Item Name: Crosstube Turning Detail

DRAWING NO. D206-667-241	TITLE CROSSTUBE ASS'Y (206B HIGH AFT)	REV. C	DART AEROSPACE LTD ENGINEERING ORDER		D.E.O. NO. D206-667-241-C-1	SHEET NO. SHEET 1 OF 1	SCALE NTS
DRAWN <i>qp</i>	CHECKED <i>AS</i>	MFG. APPR. <i>M</i>	APPROVED <i>WD</i>		DE APPR. <i>HA</i>		
DATE 11.07.15	DATE 11.08.22	DATE 11.08.22	DATE 11/08/22		DATE 11.08.22

PURPOSE:

REPLACE MAGNOBOND WITH PROSEAL.

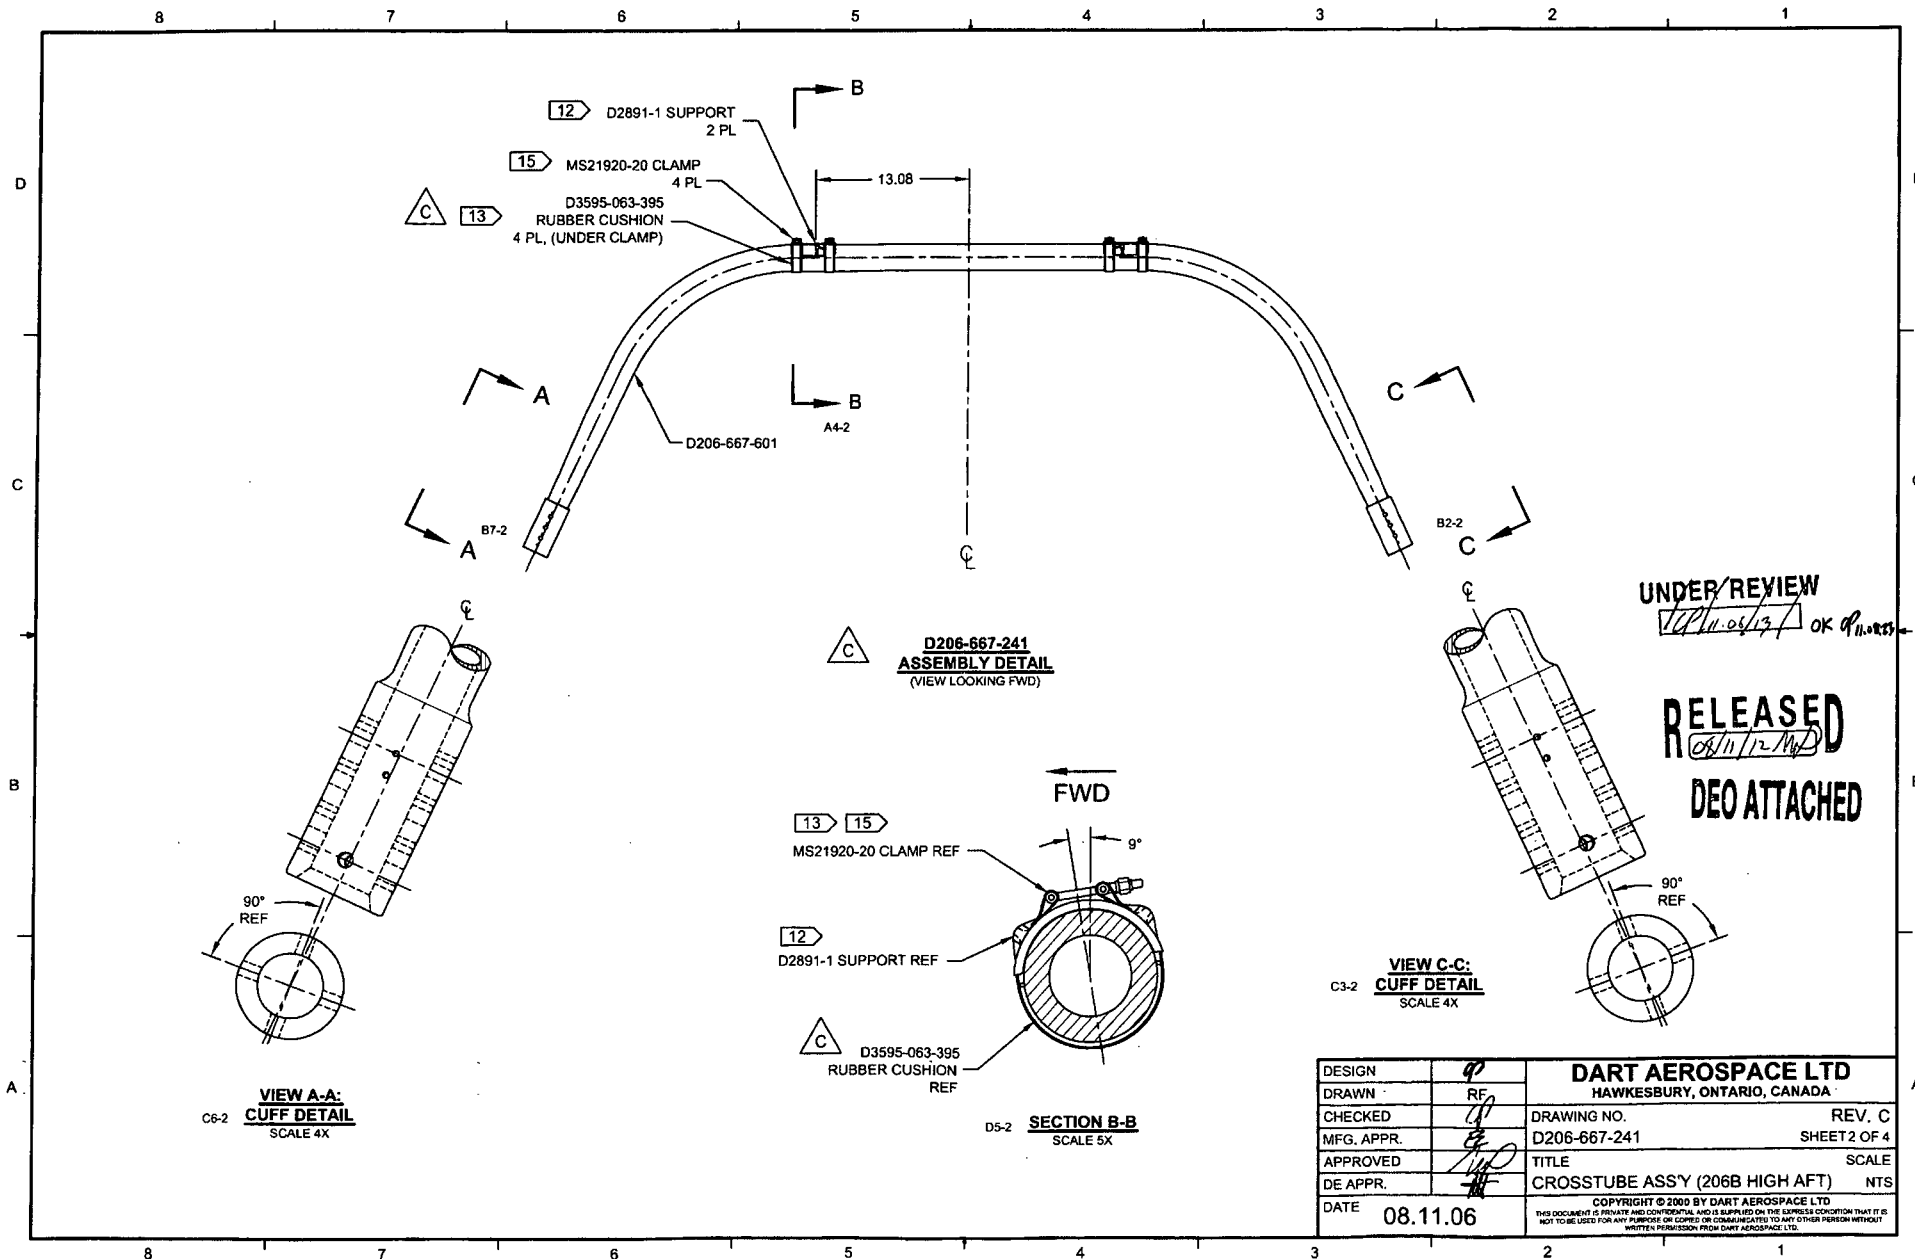
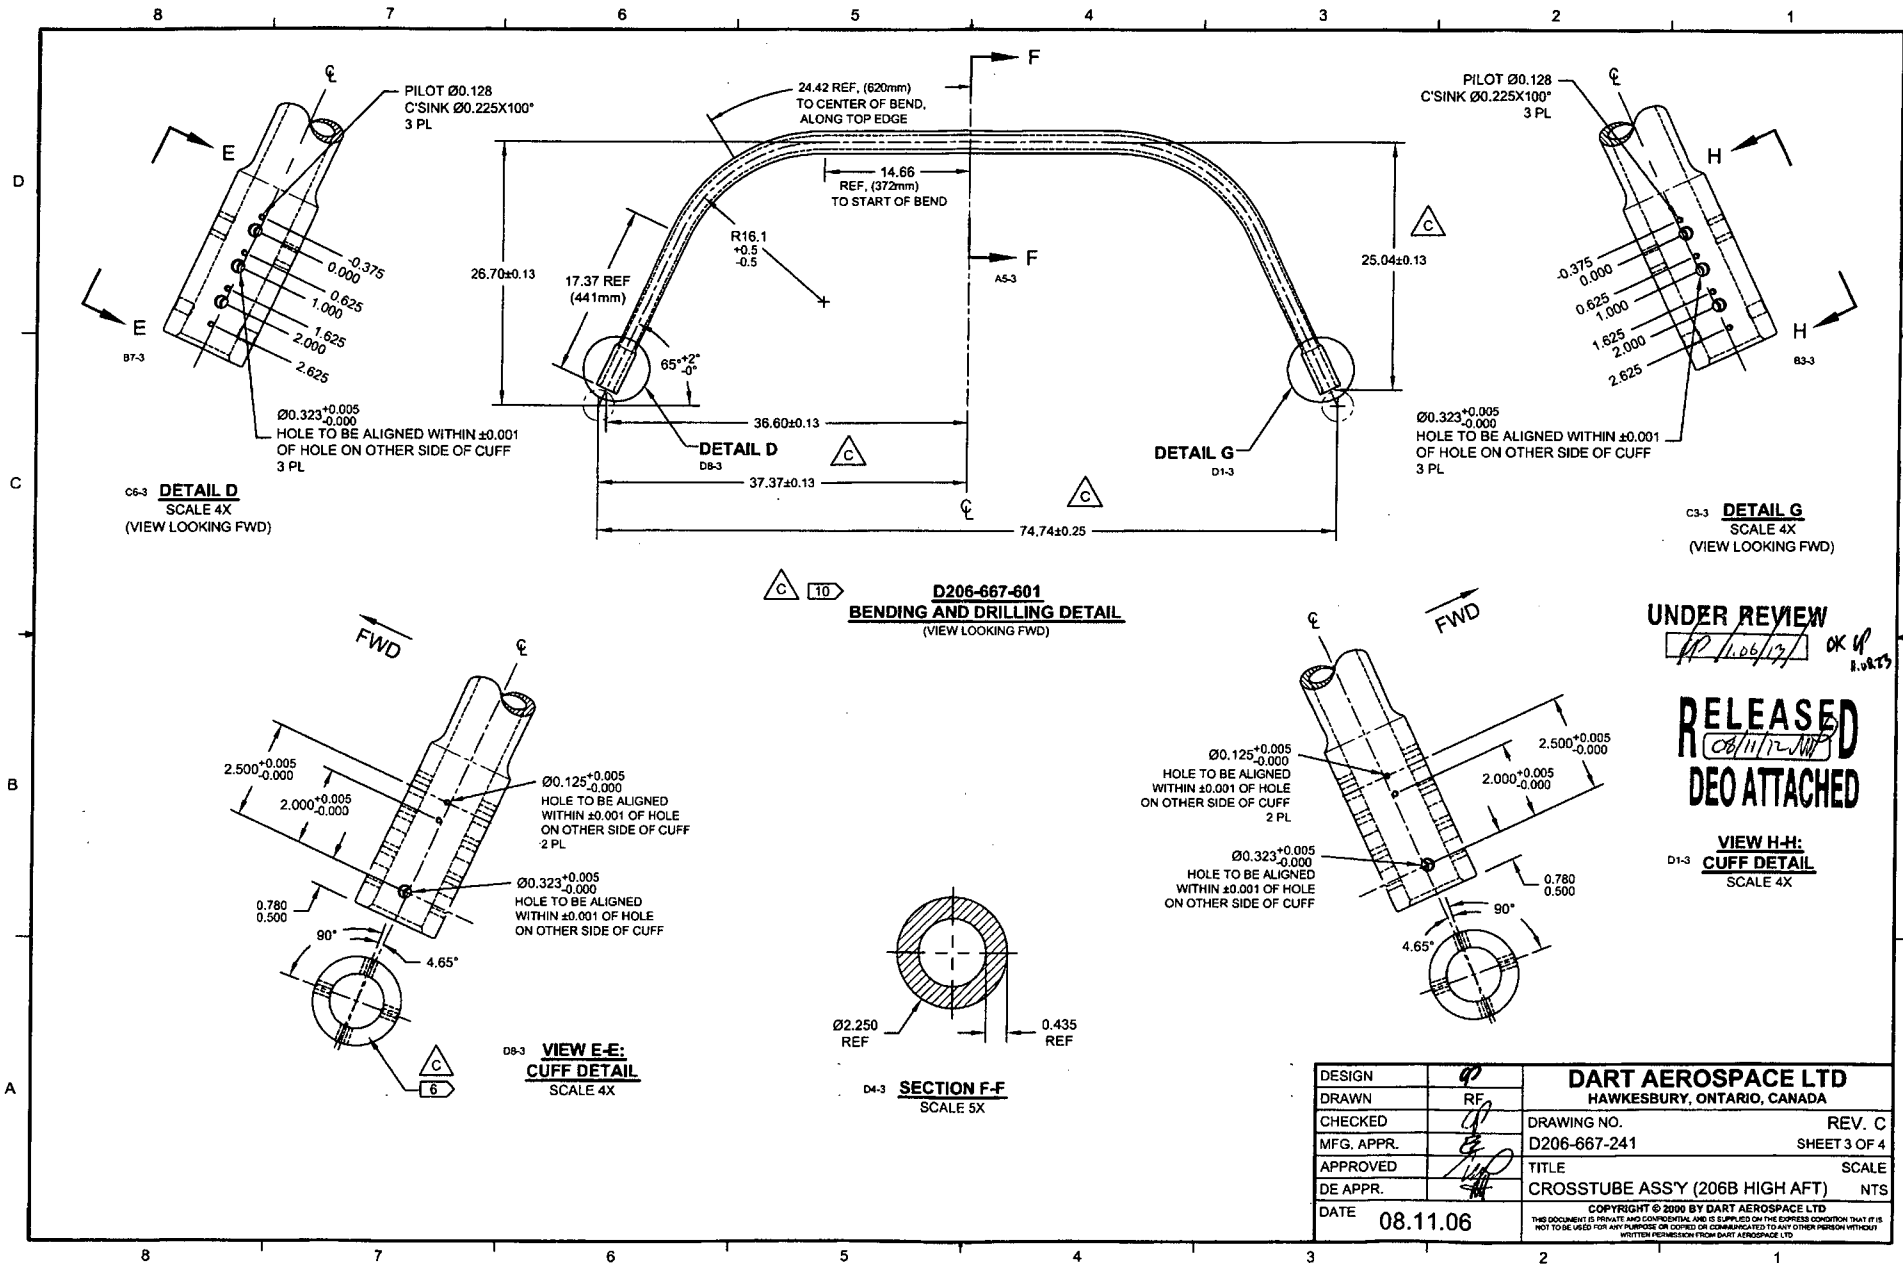
NOTE 12 & 15, SHEET 1 IS AMENDED AS FOLLOWS:

- 12) TO INSTALL D2891-1 SUPPORT: ABRABE MATING SURFACE OF SUPPORT AND CROSSTUBE WITH 180-GRIT SANDPAPER AND REMOVE RESIDUE WITH MEK (OR EQUIVALENT). APPLY A 0.04" TO 0.07" THICK LAYER OF PROSEAL 890 CLASS B-2 (OR AMS-S-8802 CLASS B-2) SEALANT TO MATING SURFACE OF SUPPORT.
- 15) TORQUE CLAMPS 80 TO 100 IN-LB. ENSURE AT LEAST 1.5 THREADS SHOWING IN SAFETY AND THAT NUT HAS NOT BOTTOMED-OUT AFTER TORQUING. **PRIOR TO PACKAGING, RE-CHECK TORQUE ON CLAMPS AFTER PROSEAL 890 SEALANT HAS CURED FOR 72 HOURS.**

- 12) INSTALL D2891-1 SUPPORT USING 0.03" TO 0.06" THICK LAYER OF MAGNOBOND 6398 PER QSI 015. LET CURE FOR 12 HOURS AFTER INSTALLATION AND PRIOR TO PACKAGING.
- 15) TORQUE CLAMPS 80 TO 100 IN-LB. ENSURE AT LEAST 1.5 THREADS SHOWING IN SAFETY AND THAT NUT HAS NOT BOTTOMED-OUT AFTER TORQUING.
